Summary of the changes made in the manuscript

Response to Review #1

The submitted manuscript describes a new airborne system for vertical measurements of aerosol optical properties, along with two measurement examples and uncertainty estimates. The revised version of the manuscript shows significant improvement compared to the previous submission; the overall presentation, structure, and readability have clearly progressed. However, several methodological clarifications, figure enhancements, citation adjustments, and technical edits remain necessary before the manuscript can be accepted for publication.

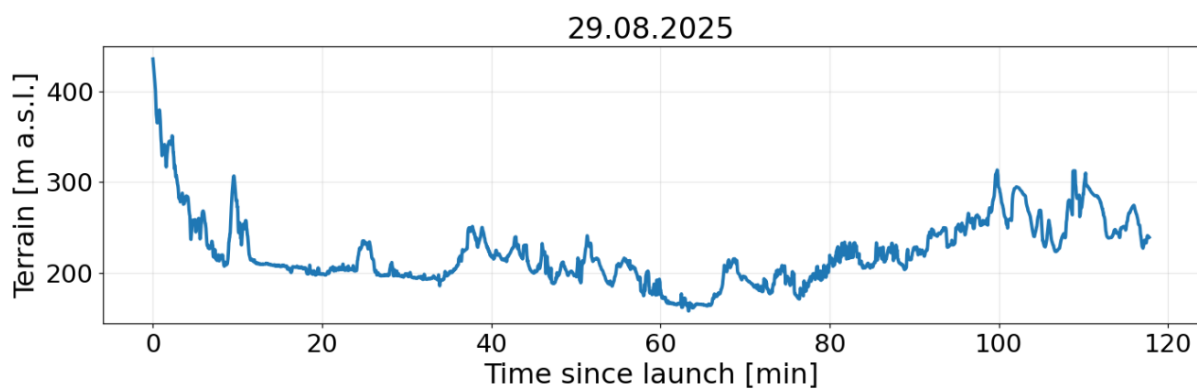
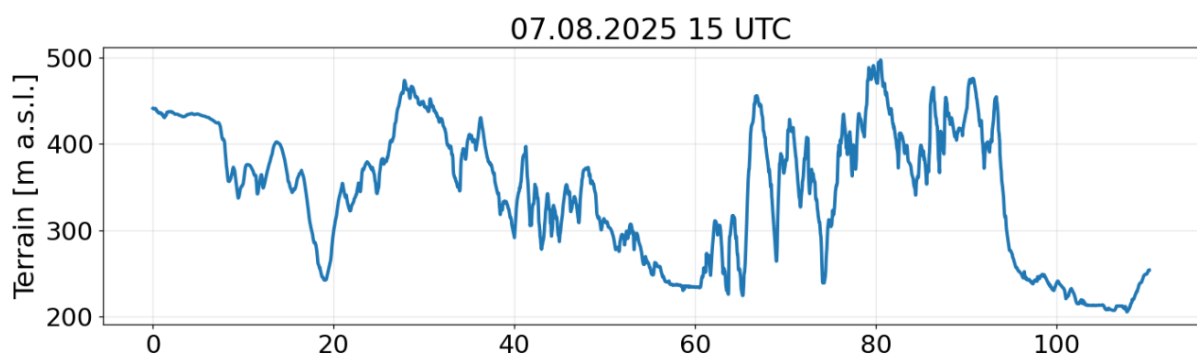
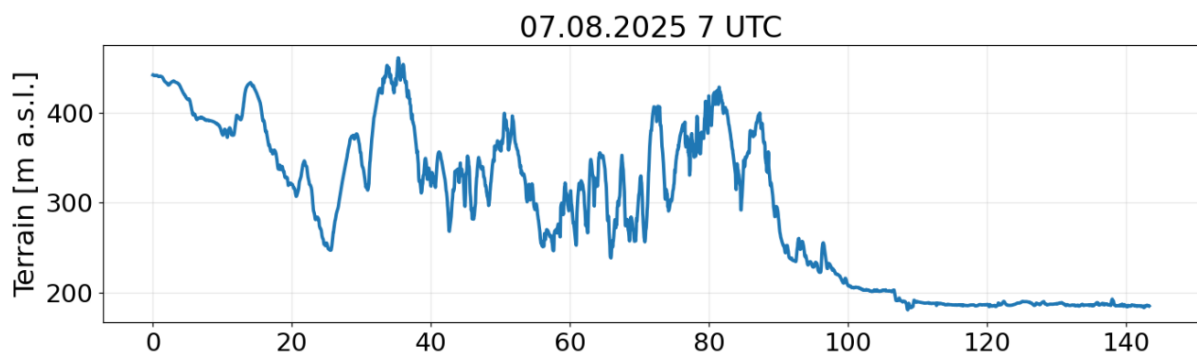
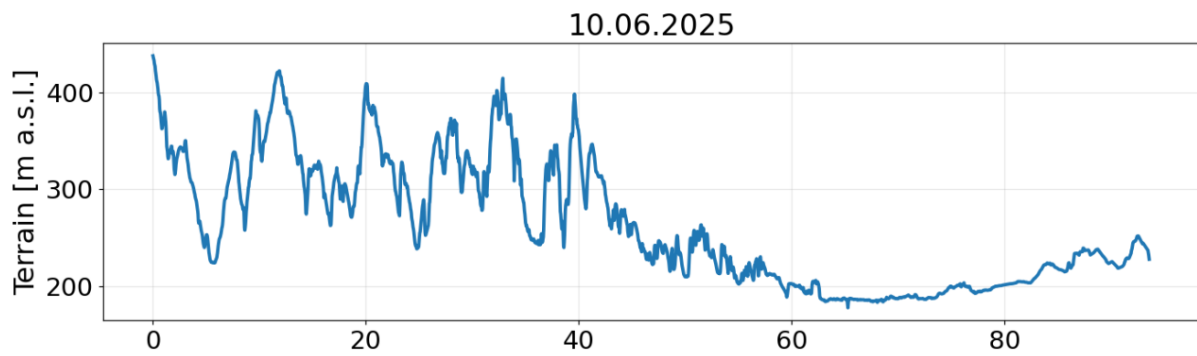
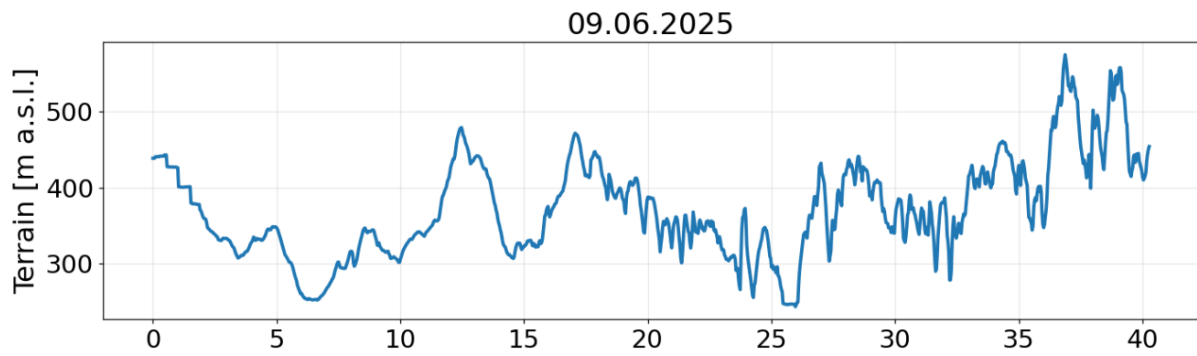
1) Considering the horizontal displacement between lidar and the AeroSonde, I would say that the orography of the region would play an important role on the stratification of elevated layers. Therefore I would recommend that the authors include an orographic map of the region, and further explain why they assume that the horizontal displacement can be neglected. This assumption is also made for the wind field (assumed to be horizontally homogeneous), which based on the orography could be wrong.

5) Lines 254-255: Was this assumption tested by the authors considering the complex terrain (elevation variations) of the region?

Re: We thank the Reviewer for this comment. We have analysed the terrain elevation directly beneath each sounding along the recorded GPS track (Figure below). The launch site is located in the Strzyżów Foothills, a hilly rather than mountainous region: along the trajectories the elevation ranges from 158 to 575 m a.s.l., i.e. it deviates by less than about 300 m from the launch site level (444 m a.s.l.). Given this moderate relief, and since the aerosol layers in the biomass-burning cases are located above 2 km, we consider the influence of the orography on their stratification to be of secondary importance. For the dust case, apart from a short descent in the first minutes after launch, the terrain beneath the trajectory remains nearly flat (elevation variability below ~100 m), which supports the assumption of horizontal homogeneity for this sounding.

Following the Reviewer's suggestion, the following sentences have been added to Sect. 2.3.2, after "It was assumed that the horizontal wind speed was horizontally homogeneous at a given altitude z ":

"To support this approximation, the terrain elevation beneath the AeroSonde was analysed (Fig. S3). The analysis showed that the terrain traversed by the AeroSonde varies between 158 and 575 m a.s.l., i.e. by less than about 300 m relative to the launch site, suggesting that the impact of the orography on the stratification of the layers in which the aerosol is found is secondary."

Re: Yes. As described in our reply to General Comment 1, we analysed the terrain elevation directly beneath each sounding along the recorded GPS track. The elevation ranges from 158 to 575 m a.s.l., i.e. it deviates by less than about 300 m from the launch site level (444 m a.s.l.), which we consider moderate enough to justify the assumption. The corresponding figure has been added to the Supplement (Fig. S3), and a supporting sentence has been added to Sect. 2.3.2.
